TECHNICAL BULLETIN

[Issue No.] T08-0011
 [Title] Notice on T-Branch Connection for CC-Link
 Communication Speed 625kbps/156kbps
 [Relevant Models] Open field network CC-Link

[Page] 1/2
 [Date of Issue] June '99

1. T-branch system configuration

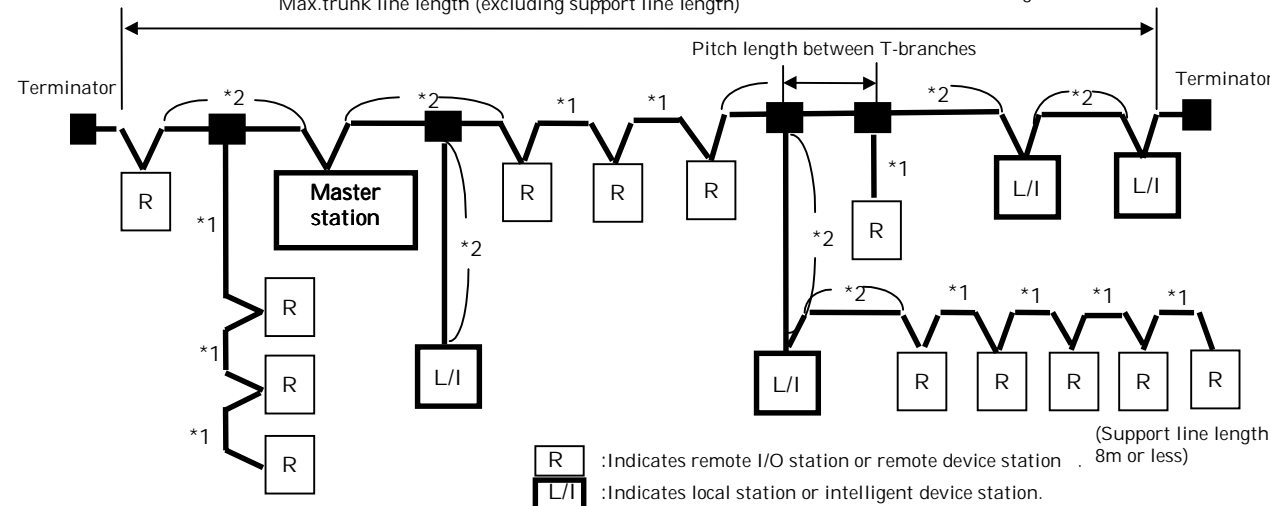
A T-branch connection can now be used for the CC-Link transmission path bus format communication speed of 625kbps/156kbps.

- Only the CC-Link dedicated cable can be used.*
 - Connect a 110Ω, 1/2W terminator across DA-DG and DB-DG at both ends of the trunk line. (The enclosed terminator cannot be used.) *
- *: Refer to specifications in section 2.
